Project Name: PPSD CTE Renovations
Project Number: 25-009

ADDENDUM NO. 1

LIFE SAFETY PLANS

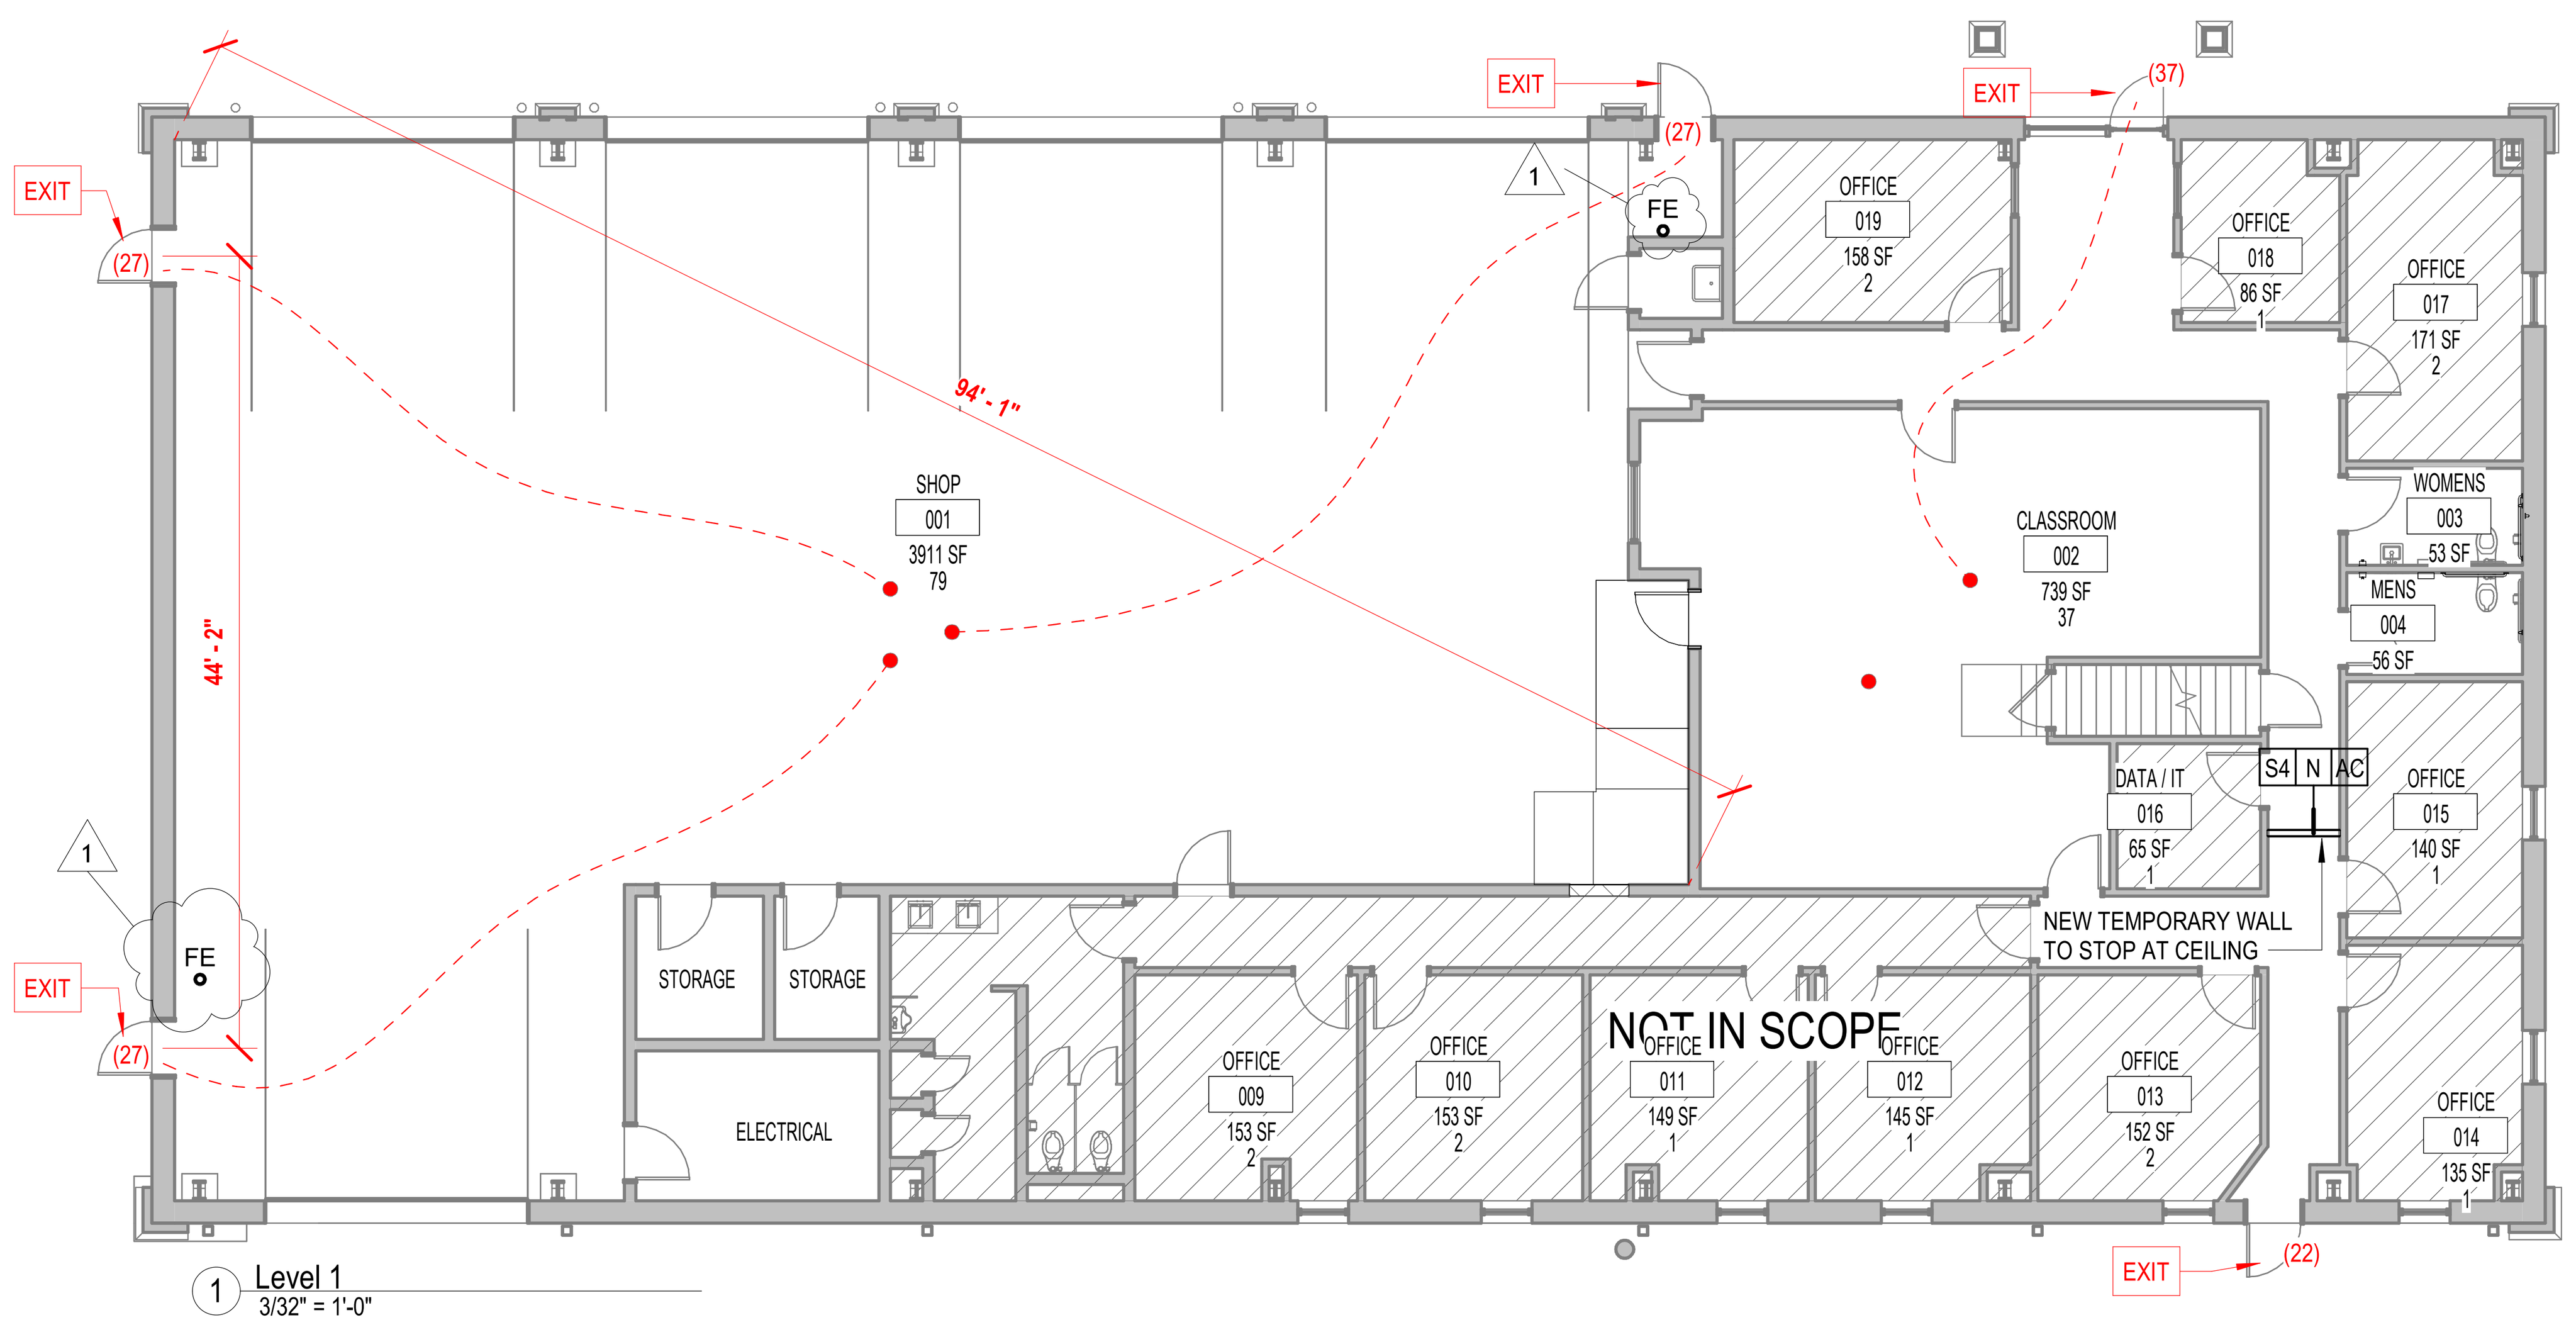
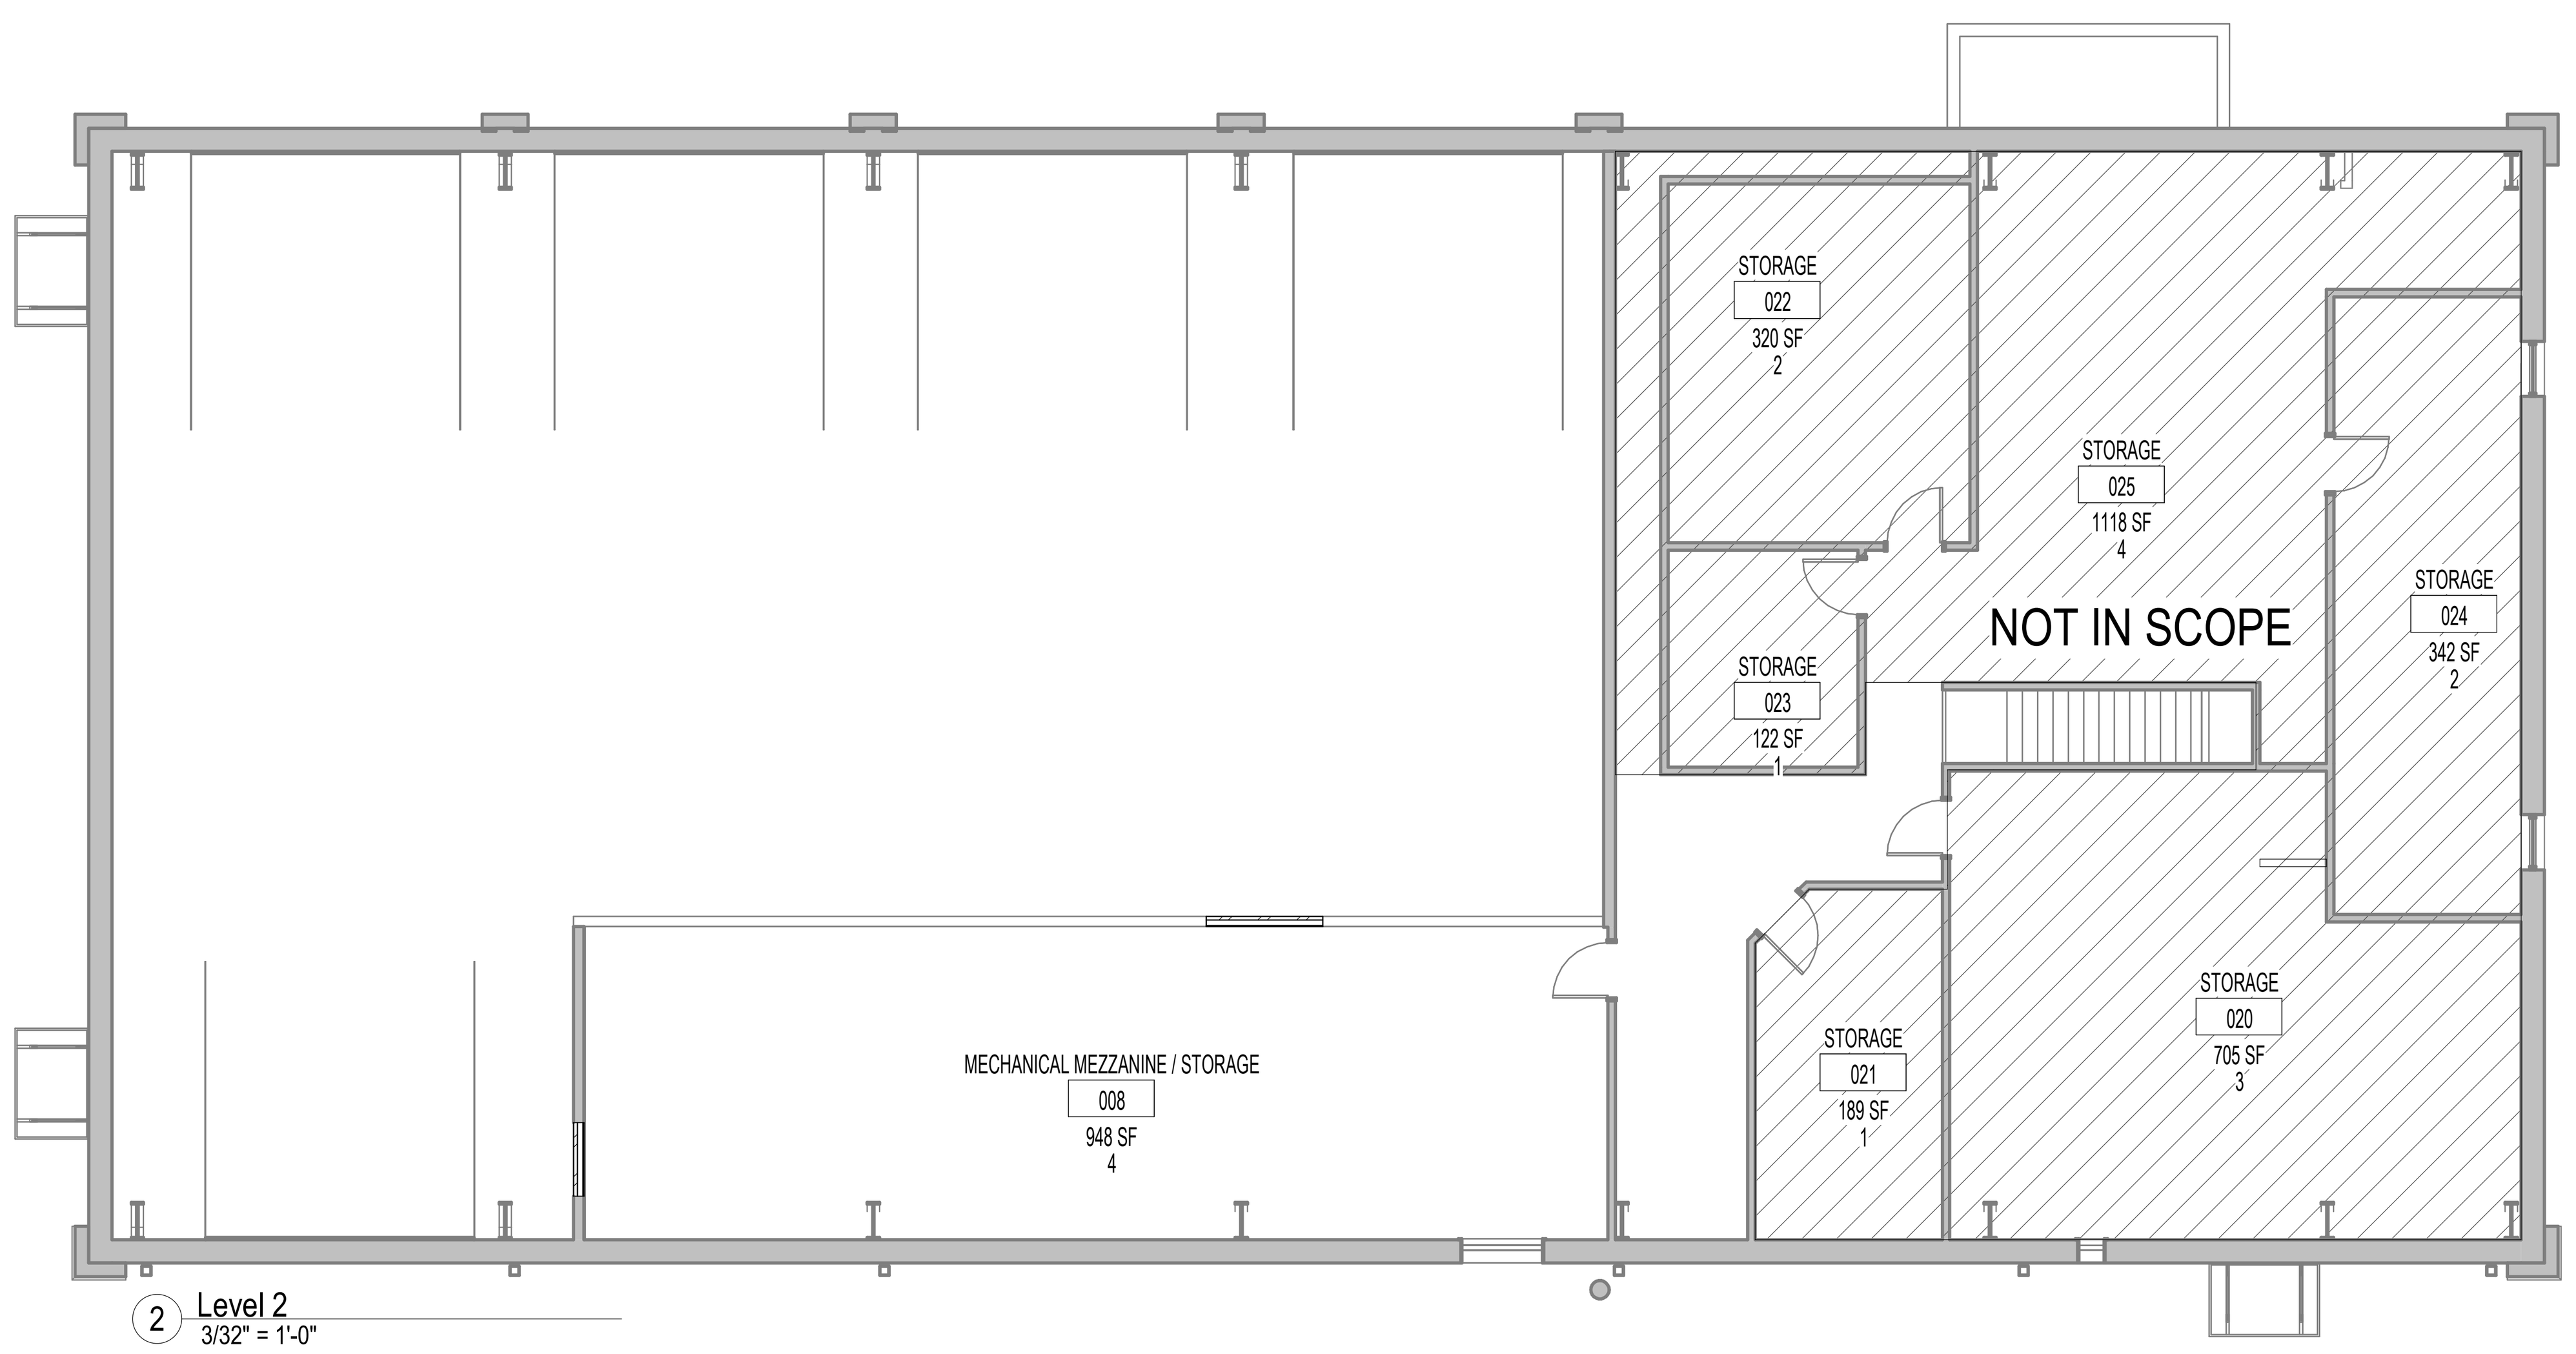
ITEM NO. 08 **Sheet R200 | LIFE SAFETY COMPLIANCE**
REPLACE sheet R200: Life Safety Compliance
Clarification: Added location of portable fire extinguishers

QUESTION 05 "Section 10.440 - Fire Protection Specialties - Please indicate quantity, type and locations for this scope of work."

ANSWER 05 See revised sheet R300 Life Safety Compliance and revised specification section 10.440 for clarification.

6 ENLARGED RESTROOM PLAN
1/4" = 1'-0"

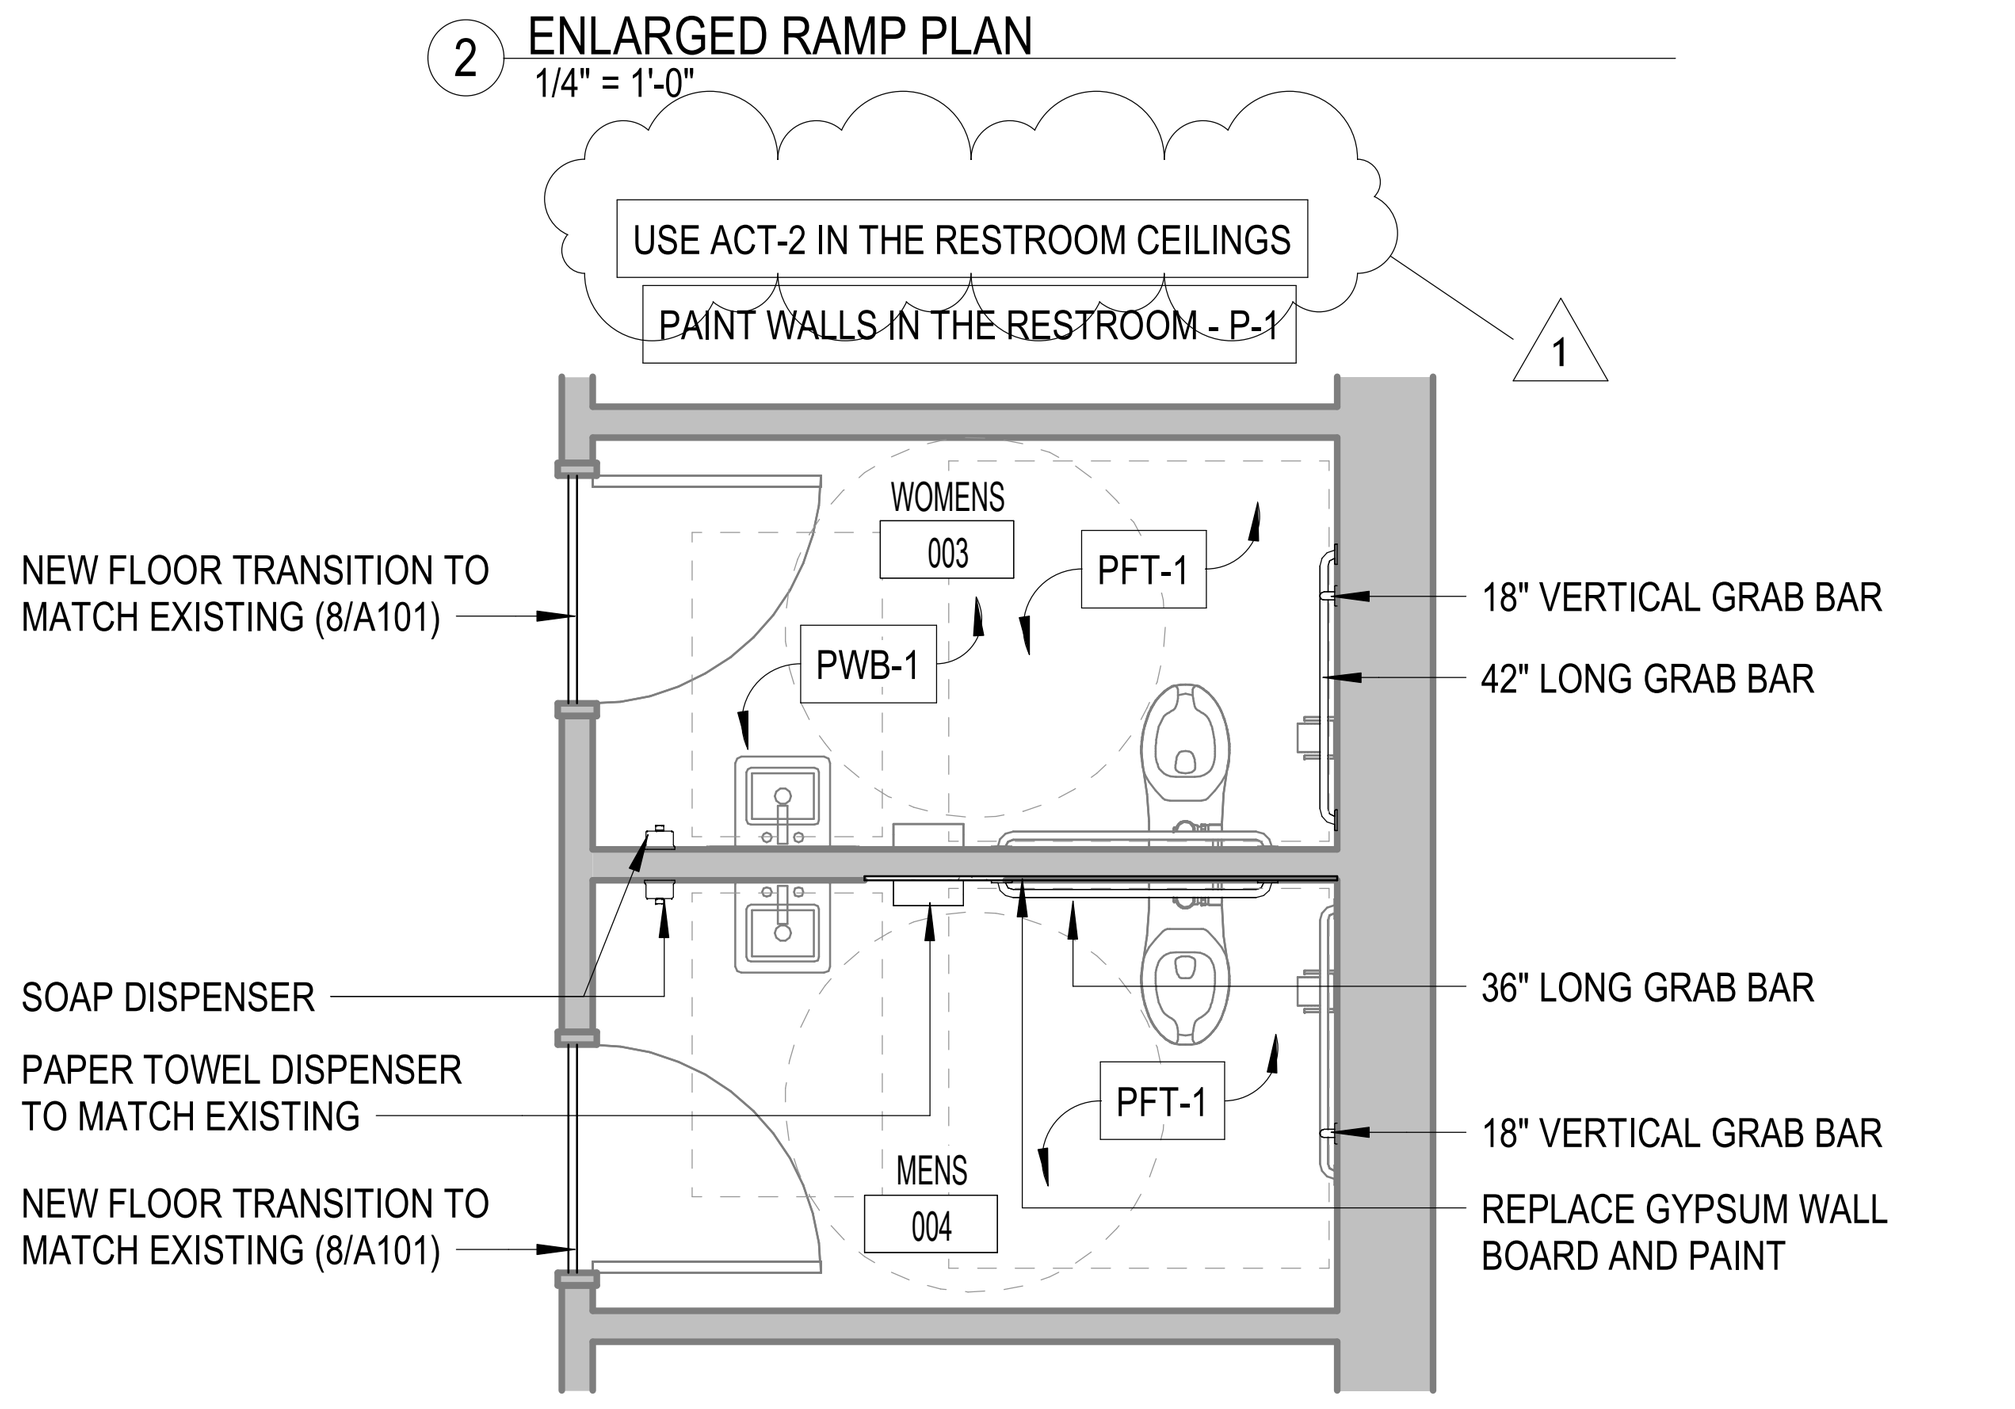
ITEM NO. 09 **Sheet A101 | FIRST FLOOR PLAN**
REPLACE sheet A101: First Floor Plan
Clarification: Revised ceiling type in restrooms

QUESTION 03 *"Drawing A101 - Finish Schedule calls out ACT 2 for the Men's and Women's Restrooms, Enlarged Plan of Restrooms notes ACT 1 to be used. Please clarify which ACT is to be used."*

ANSWER 03 See revised sheet A101 First Floor Plan for clarification
